Planning Commission Minutes
January 11, 2024

23. (PUD-1983) Application by Mustang Creek Crossing, LLC to rezone 810 South John Kilpatrick Turnpike from AA Agricultural and PUD- 1628 Planned Unit Development Districts to PUD-1983 Planned Unit Development District. Ward 3.

Amended Technical Evaluation:

STAFF REPORT
The City of Oklahoma City
Planning Commission
January 11, 2024

EXTERIOR
ELEVATIONS -
BUILDING 2

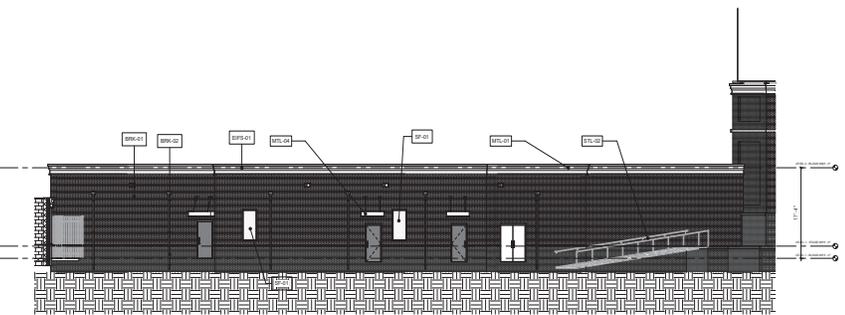
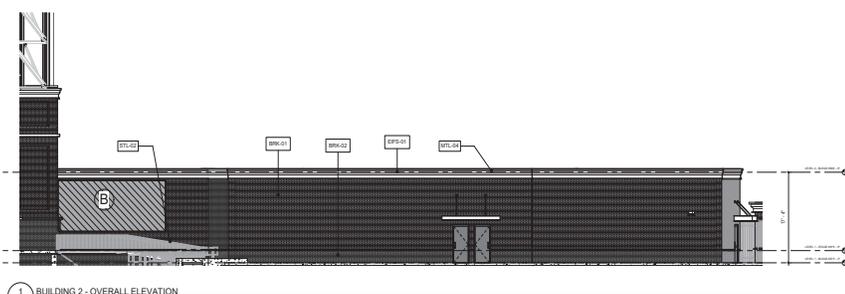
2. Specify the EMD sign allowed will be ~~EMD-2~~ EMD-3.
3. ~~Modify Section 9.12 to require an internal pedestrian access way shall be located within 150 feet of each parking space.~~

- The subject site shall meet all requirements of the City of Oklahoma City's Landscaping Ordinance in place at the time of development. Shade structures may be substituted for parking lot planting islands or peninsulas.
- Specify the EMD sign allowed will be EMD-2.
